TMC SPECIFICATION NO. S- 234

TITLE: MODIFICATION OF TUNING DRAWERS FOR FFR-2 RECEIVER JOB 336

FIG. 1

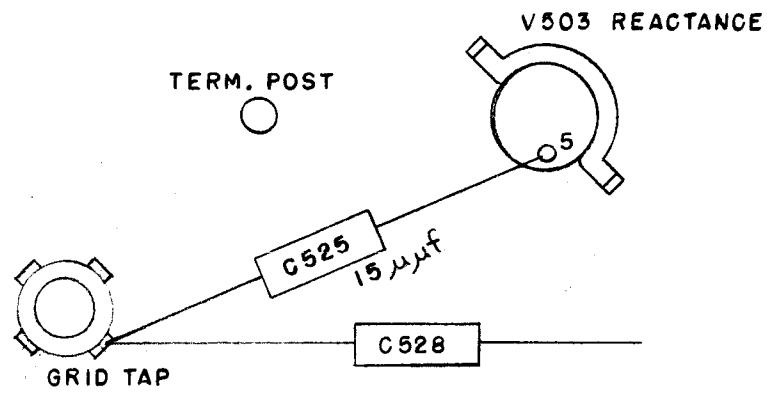
1. Remove bottom plate from Model FFRD-5. Remove capacitors C505 and C537 which are connected between feedthru's and plate lugs on R.F. and Mixer coil forms. Rewire in place parts CC21SL221J. Do not apply excessive heat to coil form lugs. Remove capacitor C525 which is wired between pin 5 of Reactance Tube V503 and a terminal post.

Connect part CC21SL150J between pin 5 of tube V503 and grid top of oscillator coil L502 as shown in figure 1. Replace bottom cover.

- (a). C505, C537 replace with part CC-101-3.
- (b). C525 replace with part CC21SL150J.

FIG. 4

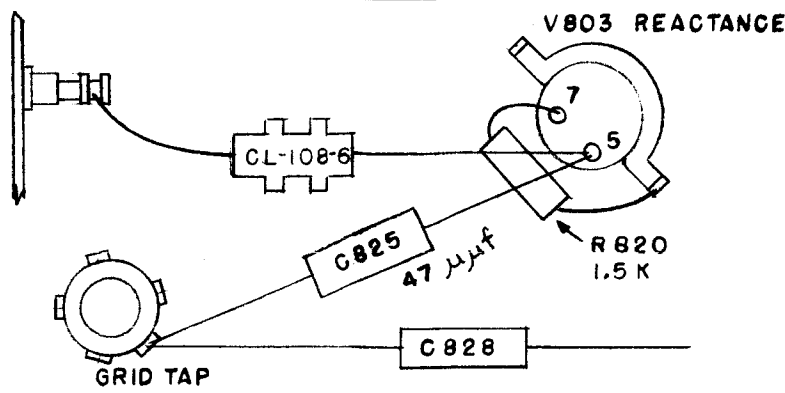
4. Remove bottom cover from Model FFRD-8. Remove R820 which is wired between pin 7 of V803 and ground. Replace with part RC20GF152K. Remove R822 which is connected between pin 5 of V803 and terminal post. Remove C825 which is connected between pin 5 of V803 and lug on oscillator coil form.

Replace R822 with part CL-108-6. Wire in part CC21SL470K from pin 5 of V803 and grid tap on oscillator coil form as shown in figure 4.  
Replace bottom cover.

- (a). R822 replace with part CL-108-6.
- (b). R820 replace with part RC20GF152K.
- (c). C825 replace with part CC21SL170K.

FIG. 2

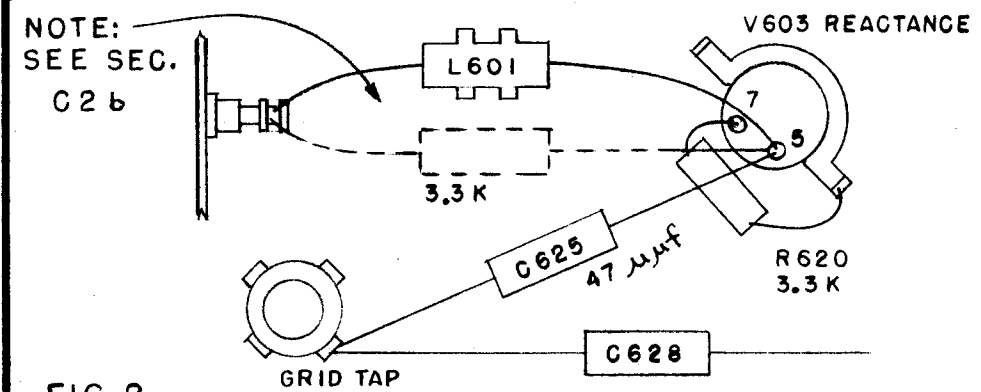
2. Remove bottom cover from Model FFRD-6. Remove capacitors C605 and C637 which are connected between feedthru's and plate lugs on R.F. and Mixer coil forms. Rewire in place parts CC21SL151J. Connect part RC20GF332K in parallel with choke L601 which is connected to pin 5 of Reactance Tube V603 and a terminal post or replace choke L601 with CL-108-7. Remove capacitor C625 which is connected between pin 5 of V603 and a terminal post. Replace with part CC21SL470K from pin 5 of V603 to grid lug on oscillator coil form as shown in figure 2. Remove resistor R620 which is connected between pin 7 of V603 and ground. Replace with part RC20GF332K. Replace bottom plate.

- (a). C605, C637 replace with part CC-101-2.
- (b). Shunt L601 with part RC20GF332K, or Replace L601 with part CL-108-7
- (c). C625 replace with part CC21SL170K.
- (d). R620 replace with RC20GF332K.

FIG. 3

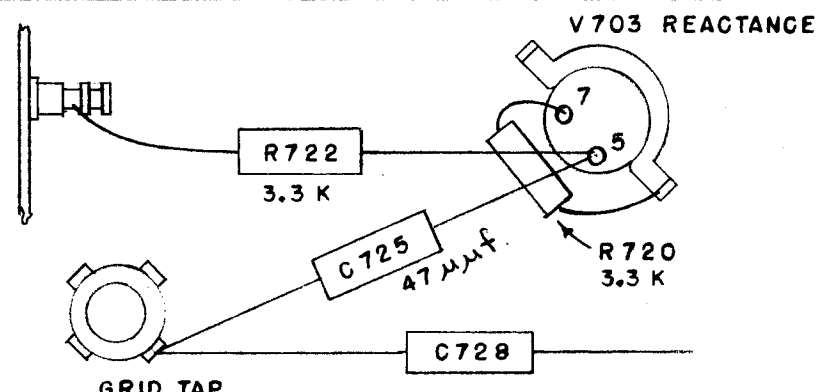
3. Remove bottom plate from Model FFRD-7. Remove resistor R720 which is connected between pin 7 of V703 and ground. Replace with part RC20GF332K. Remove resistor R722 which is connected between pin 5 of V703 and a terminal post. Also remove capacitor C725 which is connected between pin 5 of V703 and a terminal post. Replace R722 with part RC20GF332K. Rewire part CC21SL470K from pin 5 of V703 to grid lug on oscillator coil form as shown in figure 3. Replace bottom cover.

- (a). R720, R722 replace with part RC20GF332K.
- (b). C725 replace with part CC21SL170K.
